CHANGE ORDER(S) FOR Chaparral Pump Station

Change Order No. 4

(Reference RCP-003) Change to the tank overflow drainage flume: Price change of \$47,383.00, no change in time.

Request for Change Proposal RCP-003 – Tank Overflow Drainage Flume Revision

PROPOSED SITE AND YARD PIPING PLAN

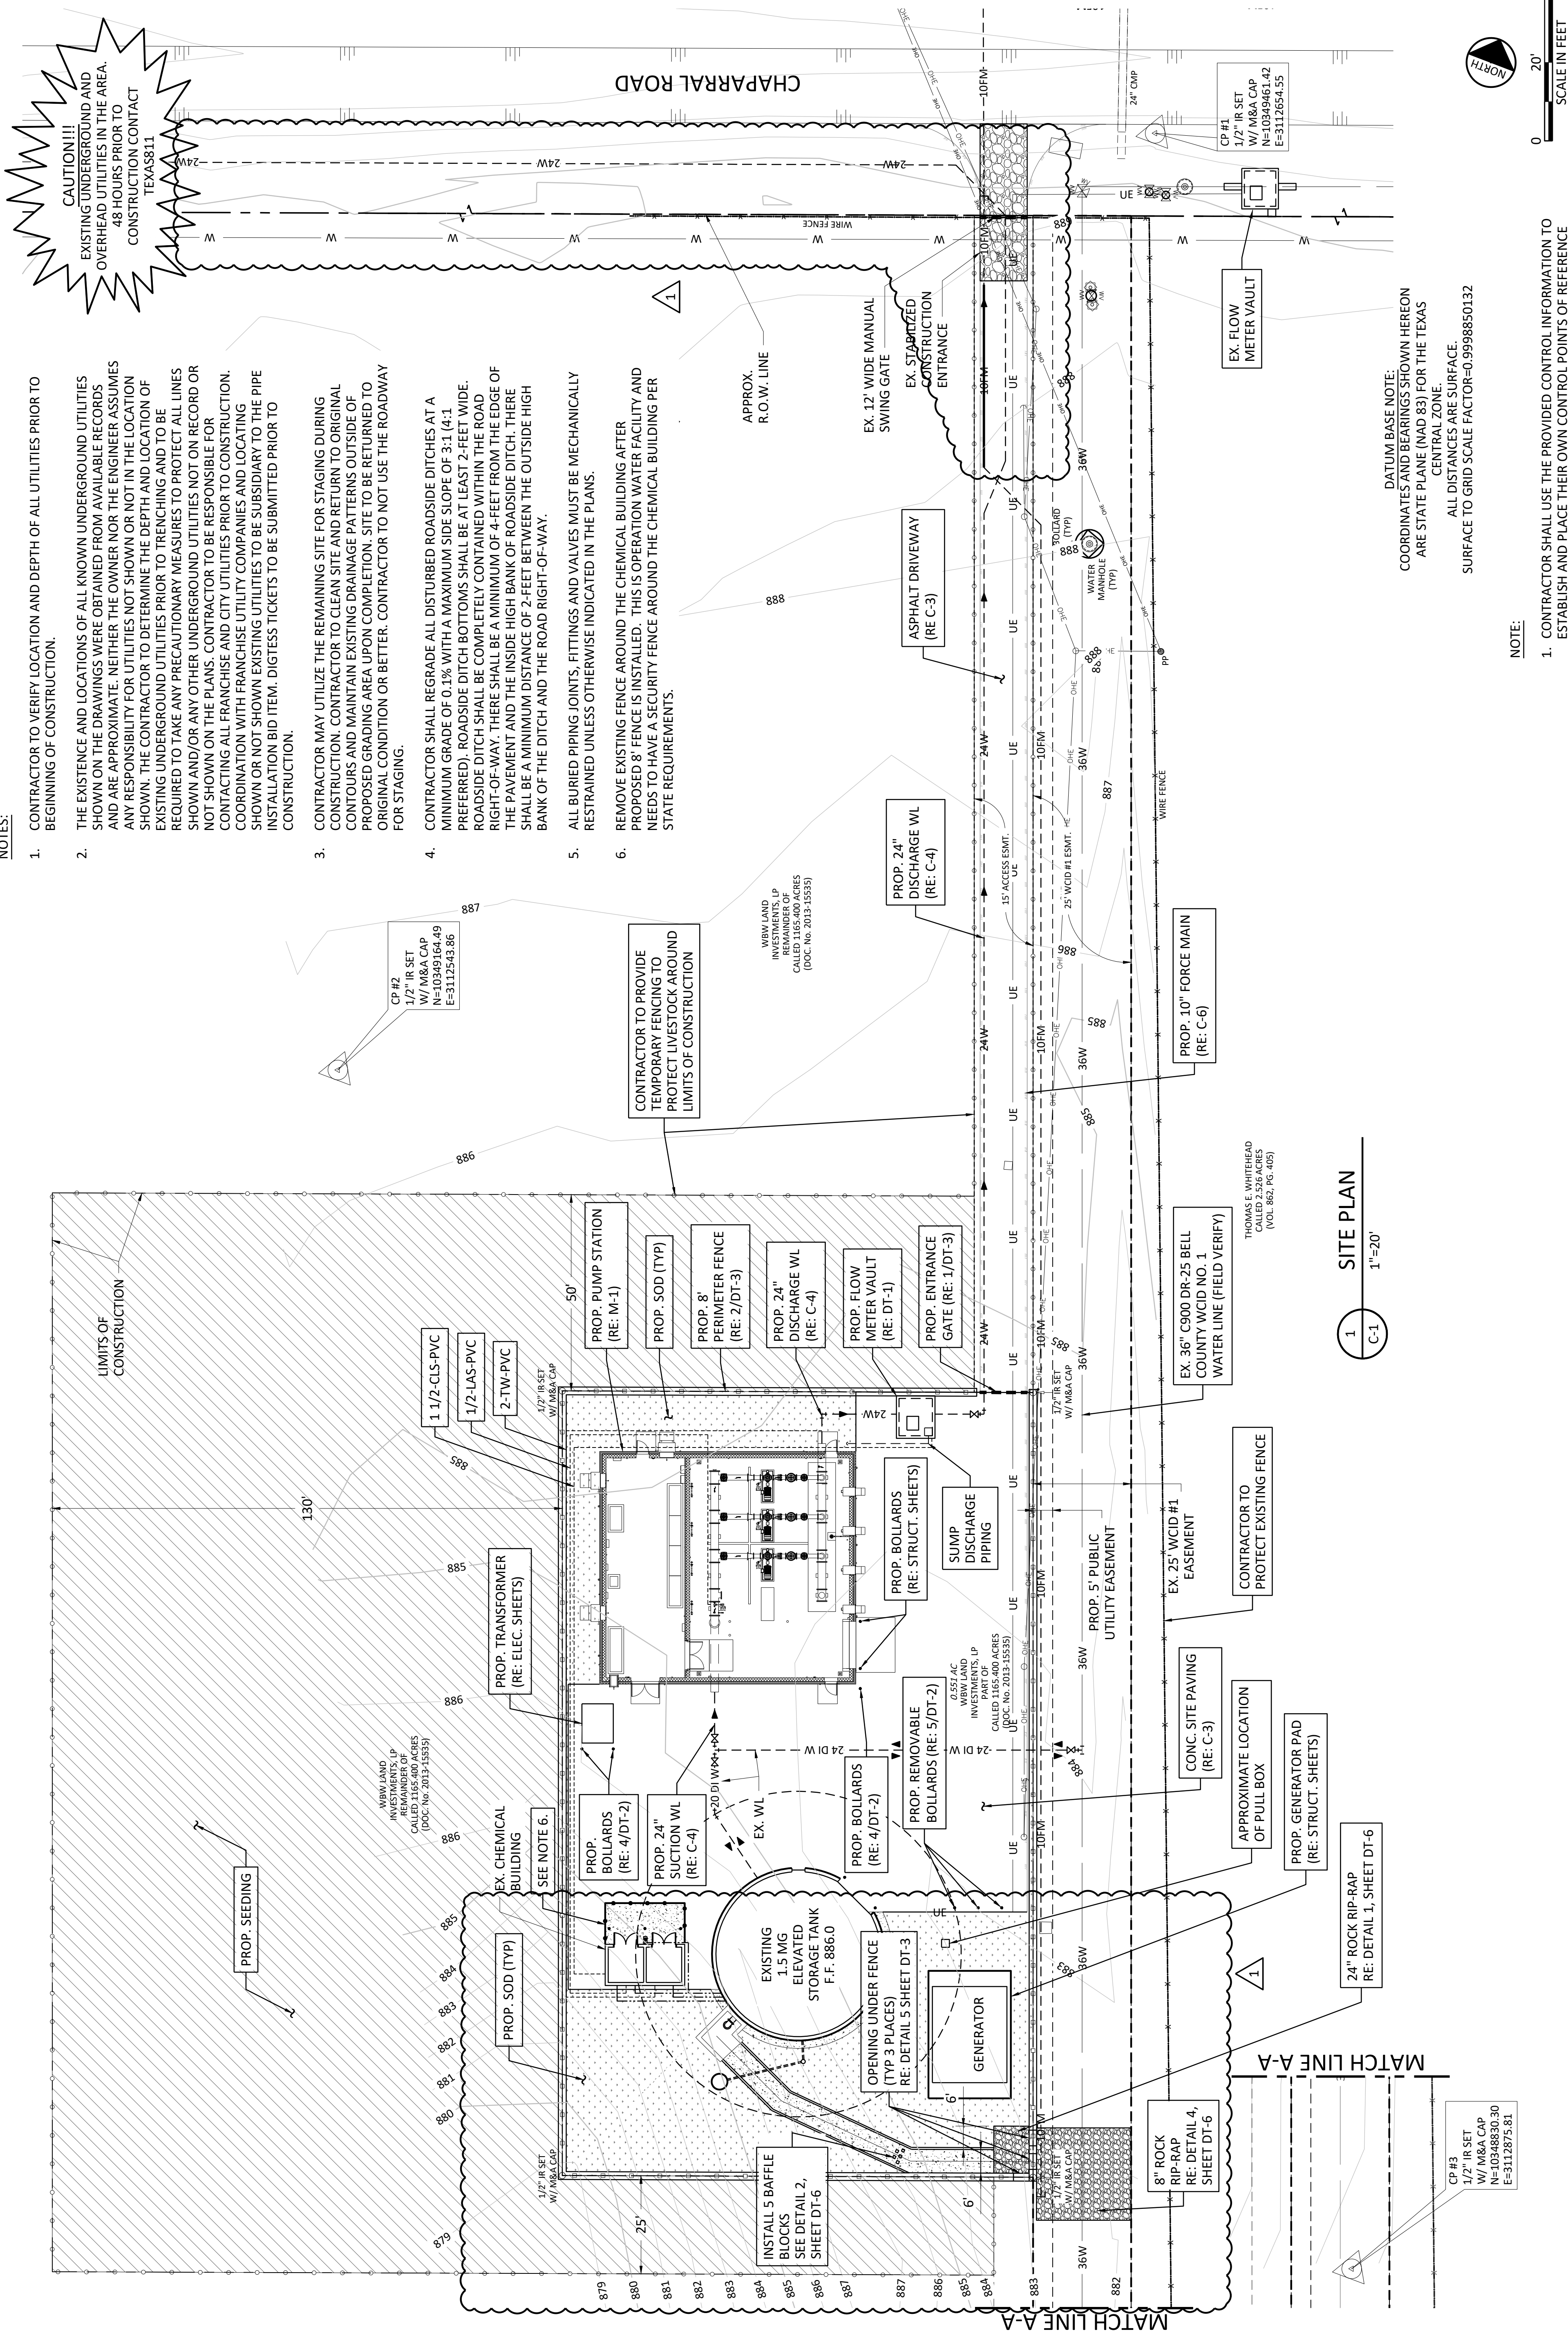
(Reference RCP-003) The tank drainage flume currently drains to an existing stock pond on the adjacent property. The adjacent property owner plans to fill the pond and develop houses. The tank drainage flume is being adjusted to slow down the flow, spread out the flow and direct the flow downstream of the stock pond.

ADD Rework EST Overflow Concrete Provide Labor, Materials, and Equipment for the following: Saw cutting existing walls and floors at EST overflow flume box, breakup saw cut concrete and prep area for new concrete with compacted native soil, form and rebar for updated floor and walls, 6 CY of concrete placement for revised floor and walls, wreck all formwork, haul off of spoils, and clean up.

ADD New Concrete Flume Provide Labor, Materials, and Equipment for the following: Saw cutting and demolishing existing flume entirely, prep proposed area with compacted native soil, form and rebar for new concrete flume, 13 CY of concrete placement for new concrete flume, (2) grating structures at fence, haul off of spoils, and clean up.

ADD New Rip Rap End Treatments Provide Labor, Materials, and Equipment for the following: 12 SY of 24" rip rap and bedding placement, 63 SY of 8" rip rap and bedding placement, haul off of spoils, and clean up.

1 24" ROCK RIP RAP DETAIL
DT-6 NOT TO SCALE

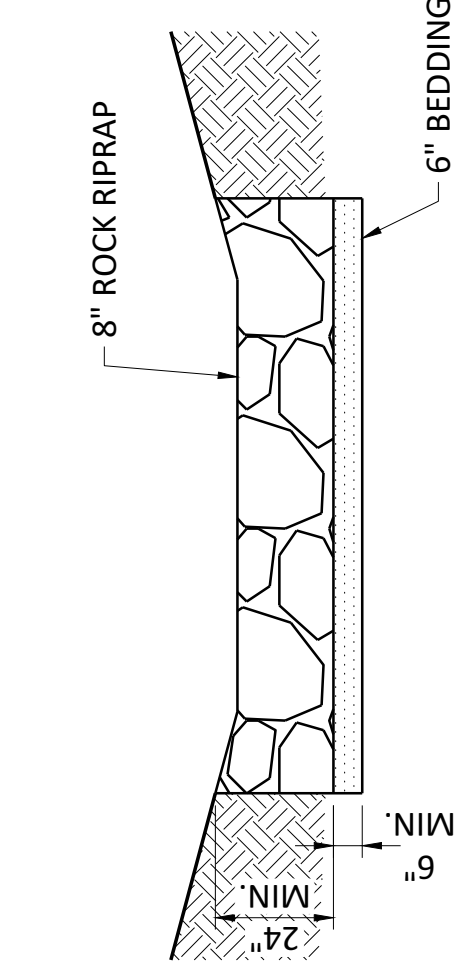
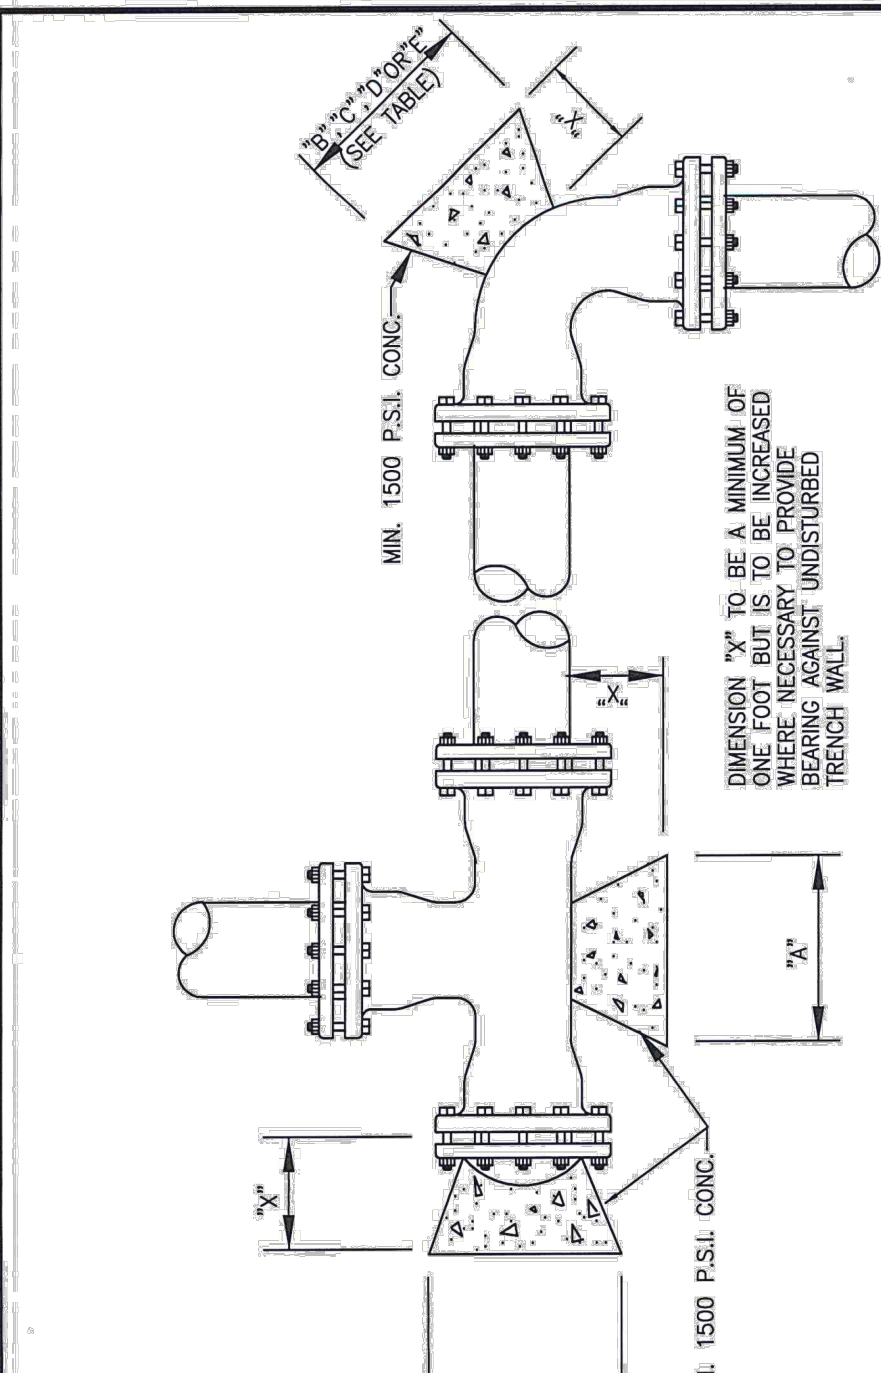
DEDUCT Rip Rap Placement at end of Flume Remove Labor, Materials, and Equipment for the following (Item no. 76 on SOV): 200 SF of bedding and rip rap placement.
